# 1993 Corvette: Service Bulletin: Transmission "Whine" Noise, Loss of Motion in all Gears, or Missing Clutch Disc Rivets

**Subject:** TRANSMISSION "WHINE" NOISE, LOSS OF MOTION IN ALL GEARS, OR MISSING CLUTCH DISC RIVETS (REPLACE TRANSMISSION CLUTCH HOUSING)

**Model and Year:** 1993 CHEVROLET CORVETTE WITH SIX-SPEED MANUAL TRANSMISSION AND 5.7L (LT1) ENGINE (VIN CODE P)

**Bulletin Number:** 37-71-40

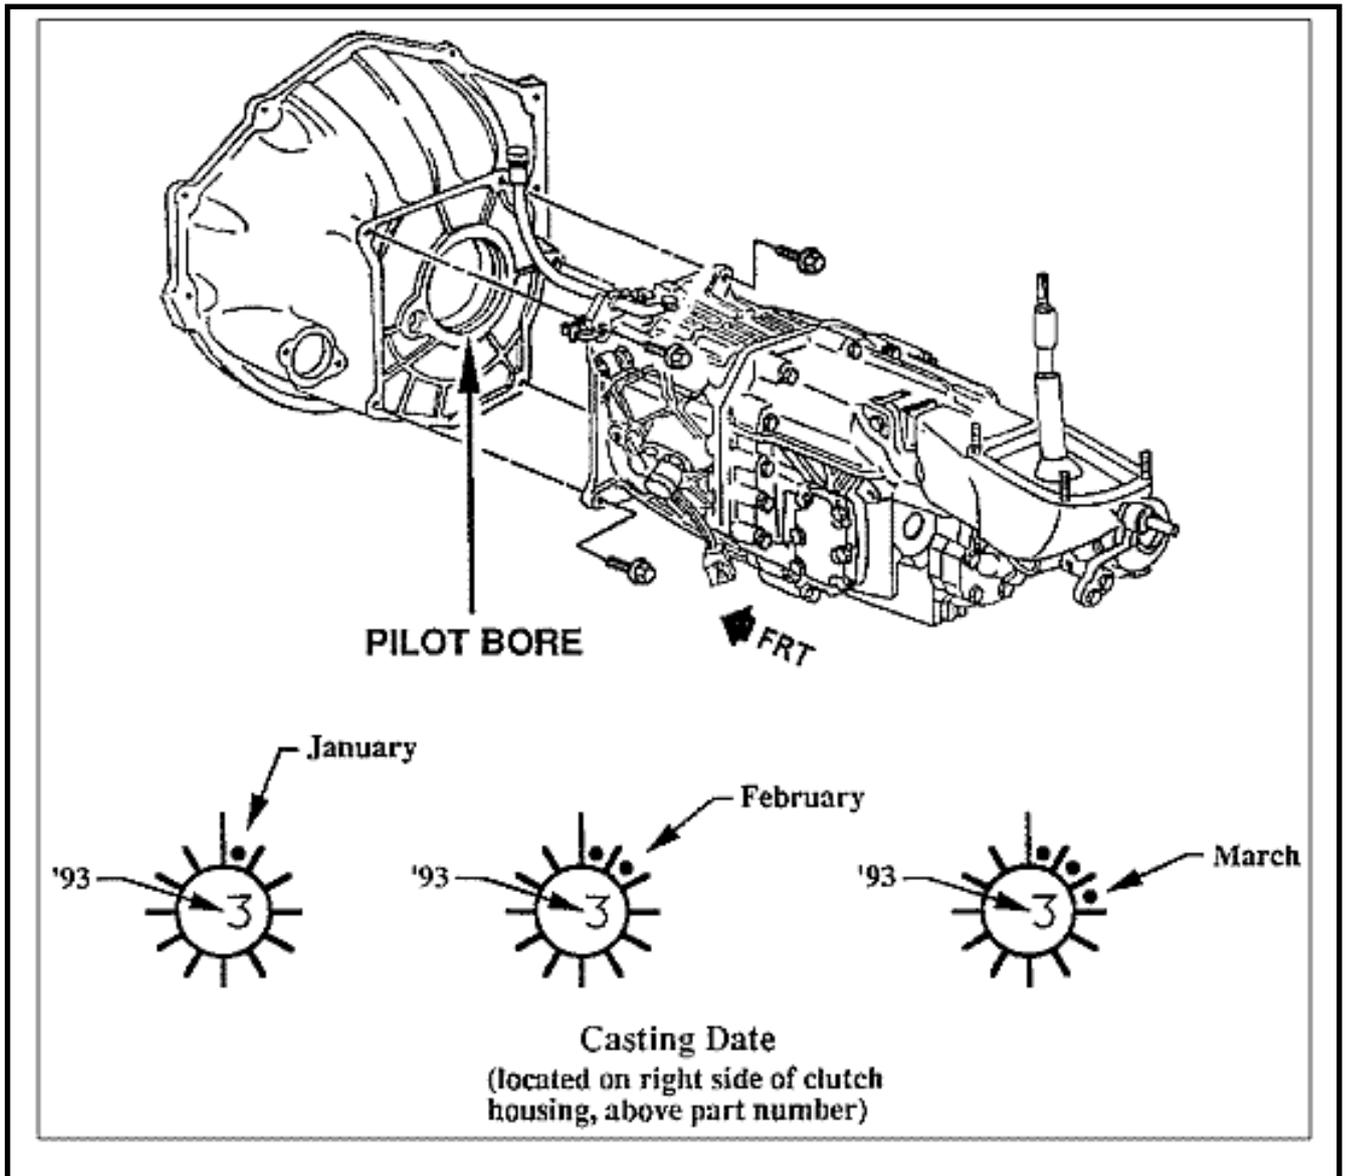
IF THE VEHICLE IS BUILT BETWEEN THE VIN BREAKPOINTS OF 110966 THROUGH 113902 AND THE CLUTCH HOUSING HAS A CASTING DATE OF EITHER "JANUARY, FEBRUARY, OR MARCH 1993", THE CLUTCH HOUSING MAY BE THE CAUSE OF THE CONCERNS. THE CLUTCH HOUSING MAY HAVE A MISLOCATED TRANSMISSION TO CLUTCH HOUSING PILOT BORE. SEE FIGURE.

THIS MISLOCATED PILOT BORE MAY SIDeload THE TRANSMISSION'S INPUT SHAFT, THEREBY PRODUCING THE "WHINE" NOISE.

THE ABOVE CONDITION MAY ALSO SHEAR THE RIVETS OF THE CLUTCH DRIVEN DISC CAUSING THE CLUTCH DRIVEN DISC FRICTION FACING TO BE DISENGAGED FROM THE SPLINED HUB.

VERIFY THE SUSPECT CLUTCH HOUSING HAS A CASTING DATE OF EITHER "JANUARY, FEBRUARY, OR MARCH 1993". NOTE: SUSPECT HOUSINGS WILL HAVE NO MORE THAN THREE (3) "DOTS" IN THE CAST DATE. SEE FIGURE.

AFTER ABOVE VERIFICATION, REPLACE CLUTCH HOUSING, P/N 10126448. PARTS ARE CURRENTLY AVAILABLE FROM GMSPO.

NOTE: IF THE VEHICLE REQUIRES A REPLACEMENT OF THE CLUTCH DRIVEN DISC DUE TO SHEARED RIVETS, THE CLUTCH HOUSING \*\* MUST \*\* ALSO BE REPLACED.
